79-91 Macpherson Street Warriewood (DA NO353/12, 2013SYE001)

79-91 MACPHERSON STREET WARRIEWOOD (DA N0353/12)

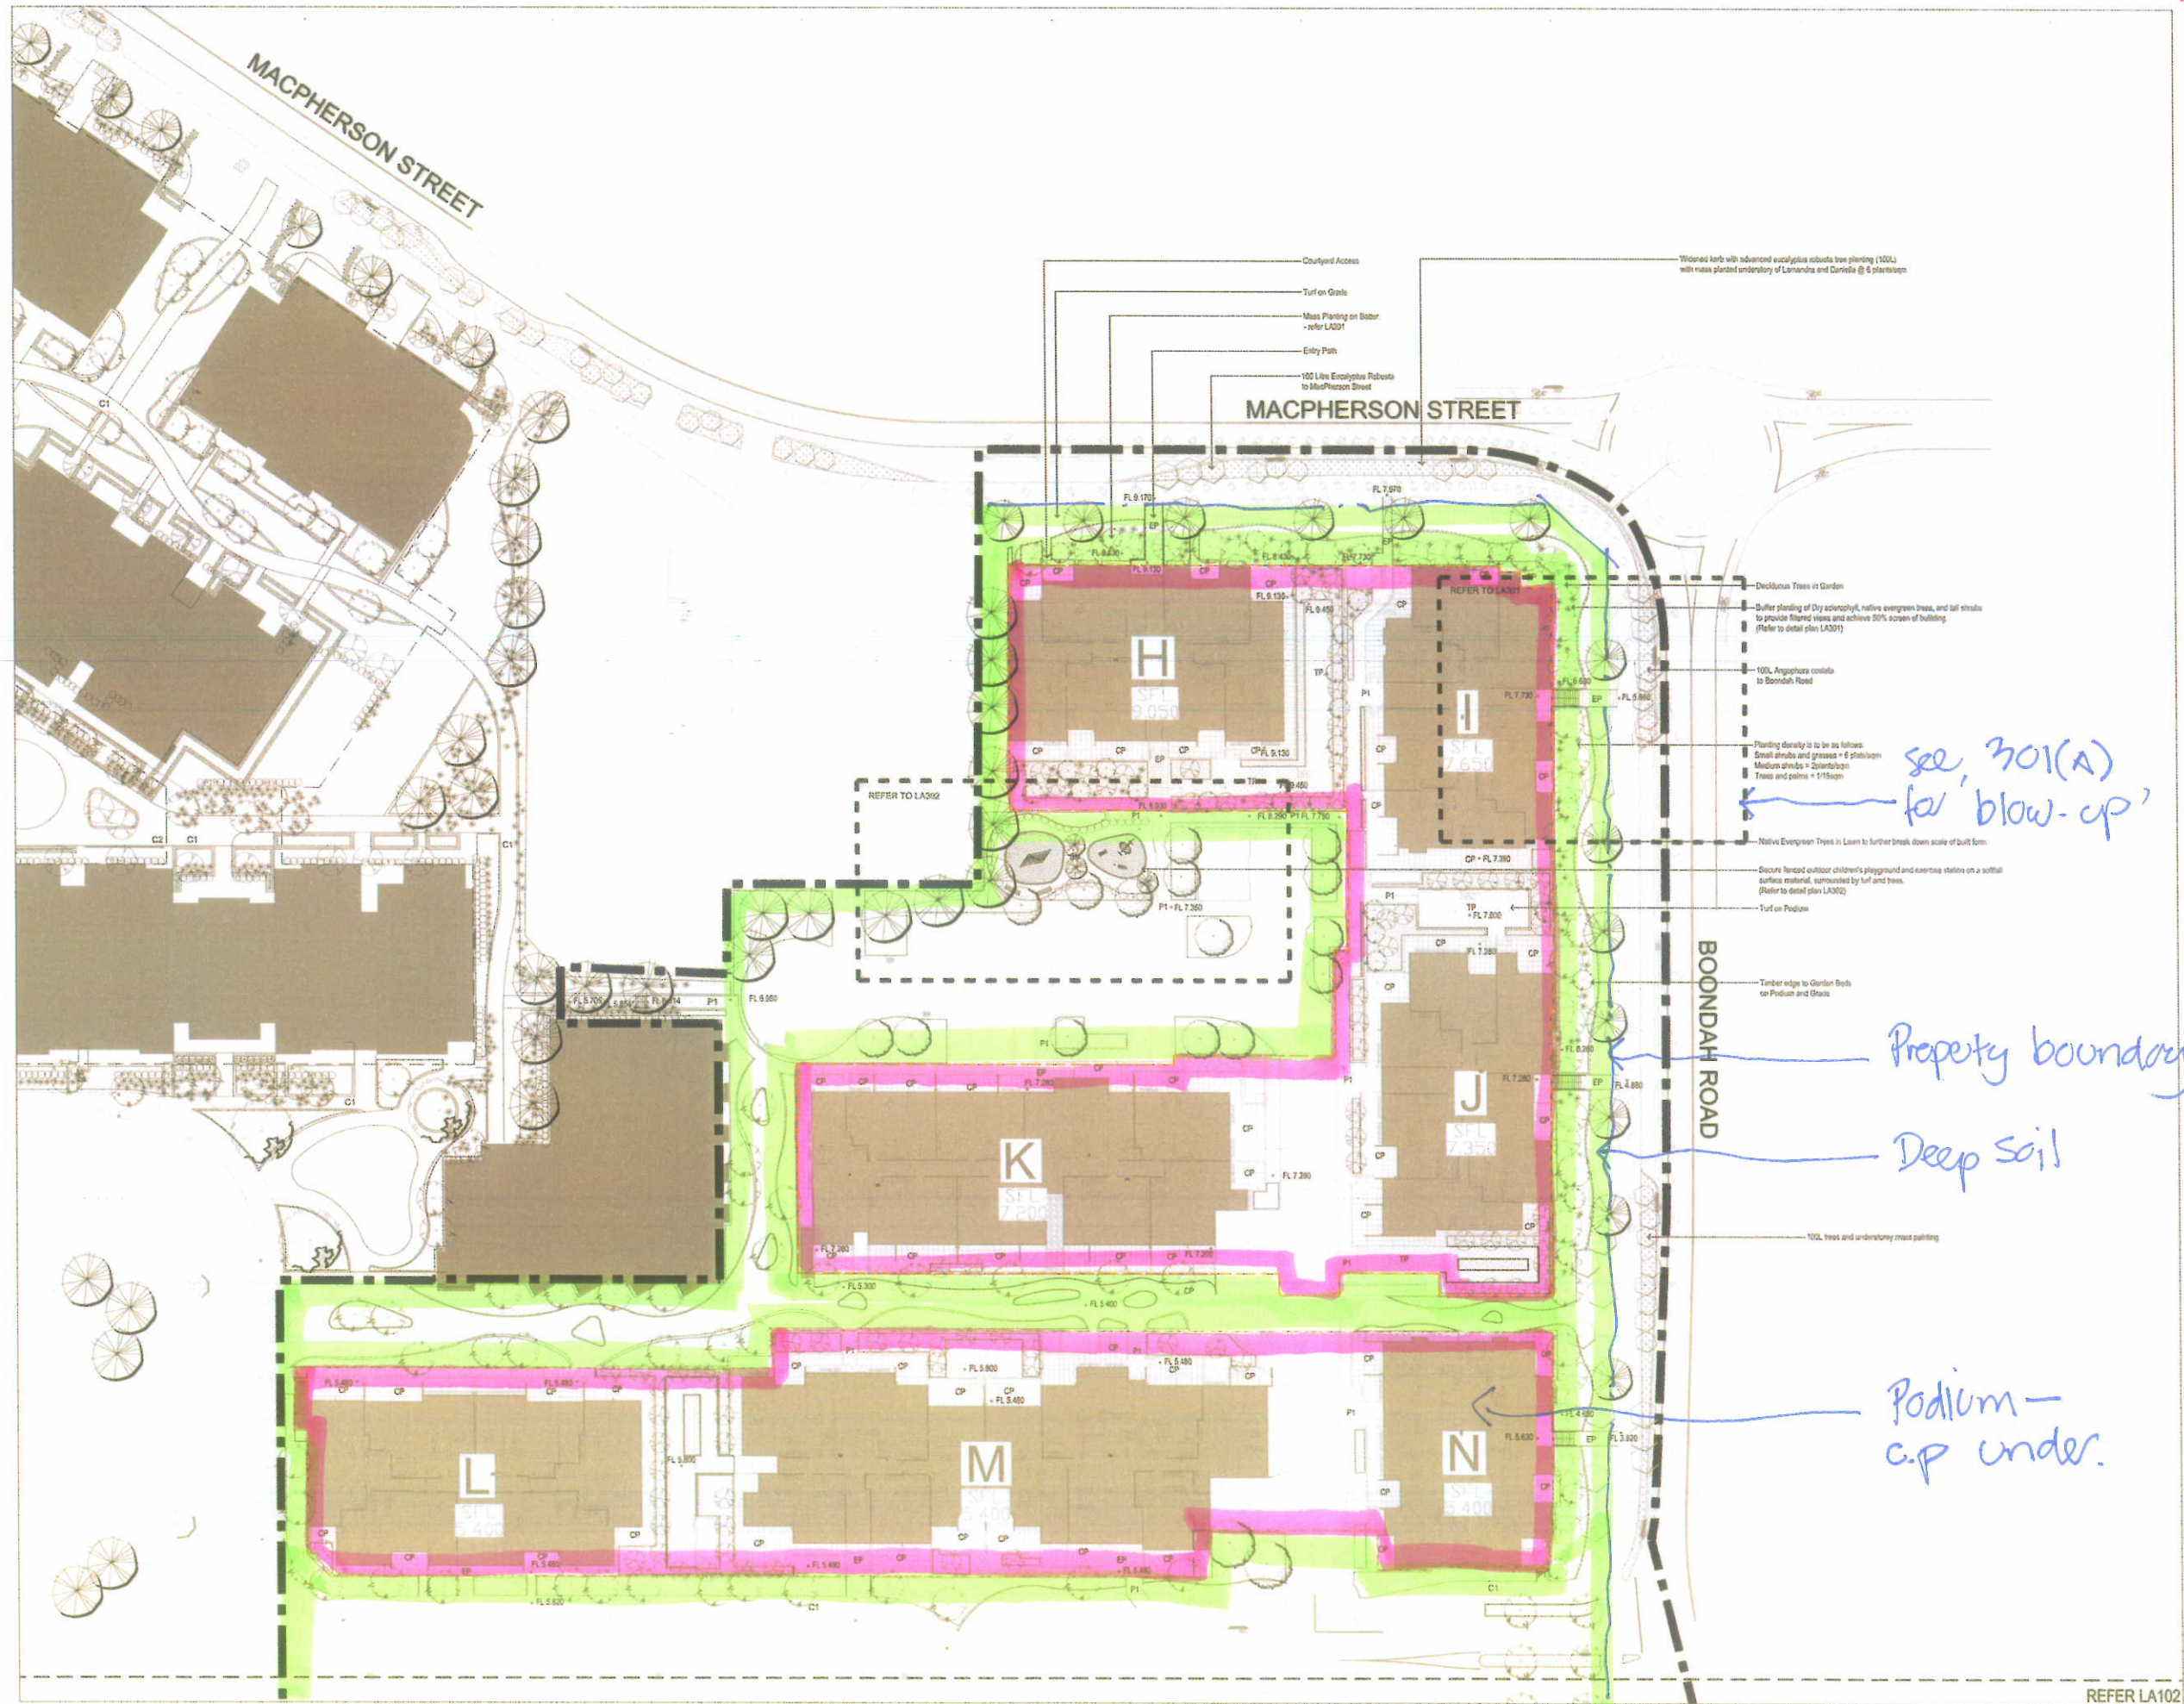
The deferred commencement conditions relate only to flooding and landscaping. In regard to the landscaping conditions, they have no bearing on commencing work on site and can therefore be placed in the main body of conditions. This way, we can amend the landscape plans whilst work on site is underway.

With regard to flood management, approval has already been granted by the Planning and Assessment Commission (PAC) for the whole site and is also supported by Council in proposed condition 11 of the main approval notice. Council should therefore be comfortable with deleting the deferred commencement requirements and rely on the PAC approval which is outlined in proposed condition 11 that has been prepared by your staff.
